Our Ref: 2025-912

RE: [REDACTED] – **Highway Observations**

I refer to your Highway Observations in response to [REDACTED] query relating to [REDACTED] that also references Planning approval for P2016/0554 at Erw Fair, Tirbach Road, Ystalyfera, Swansea, SA9 2HX.

2020

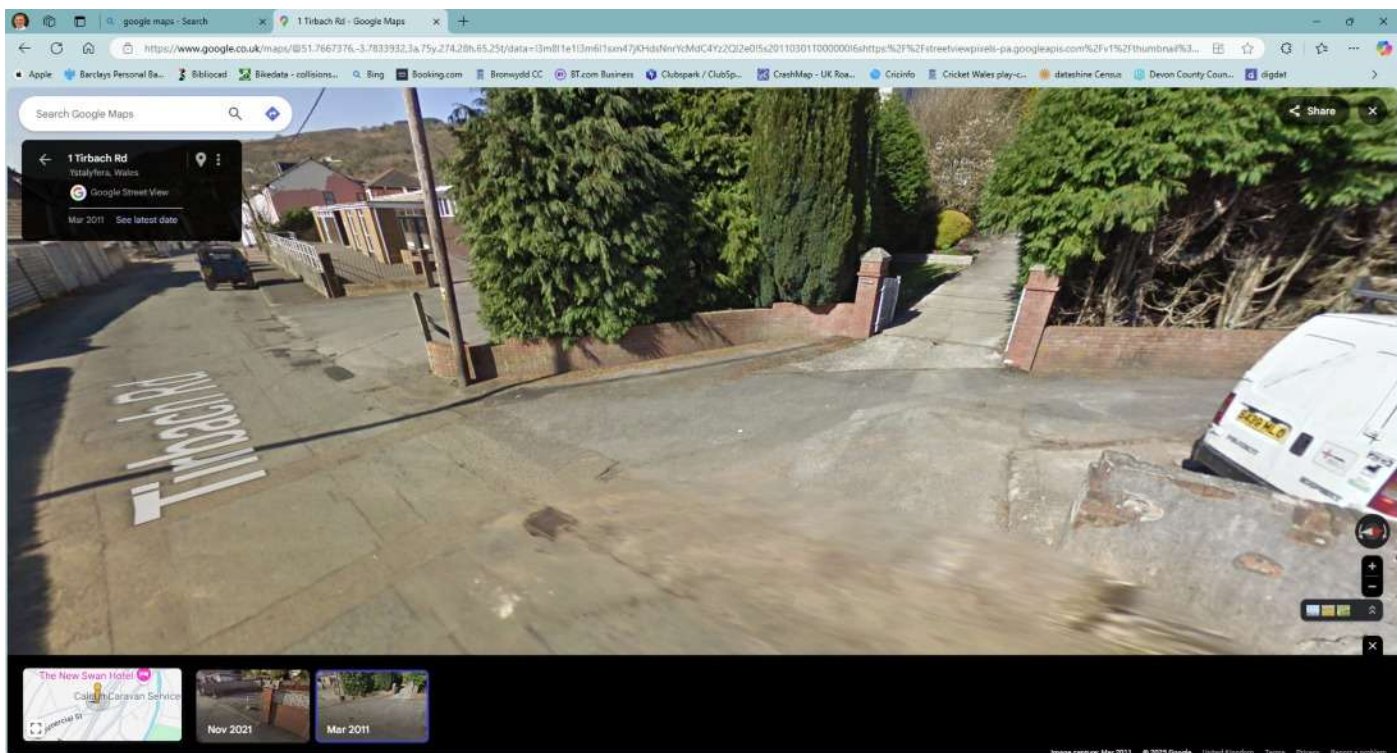
1. This is not a new access it is an existing access and there are no land use changes. Unfortunately, the suggested vehicular visibility splays can not and have never been achievable. Evidence of this can be seen from looking at the historical Google Earth images and historical Google Street view images and also the Council has recently painted 'H' bars across the driveways along Tirbach Road.

These images are taken from Google Earth and Google Maps. They show that the access driveway to Dan-y-Coed and Erw Fair is existing and that there has been no change to the driveway entrance at Tirbach Road from 2006 to 2021 and no amendments to the driveway are proposed.

Google Earth Street View 2021

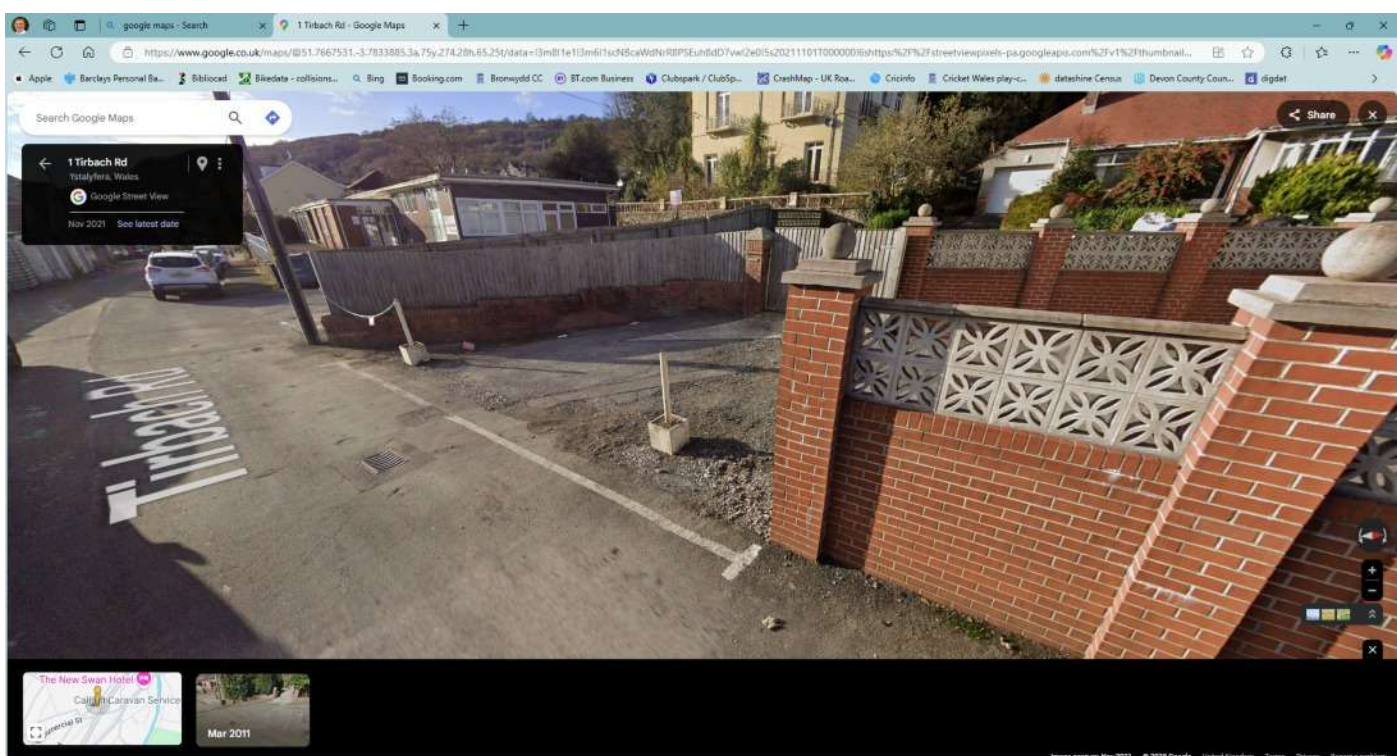
It is only proposed to erect gates across the entrance to stop visitors to the Clinic from parking within the driveway and dumping their rubbish in the driveway protecting the environmental amenity of the residents.
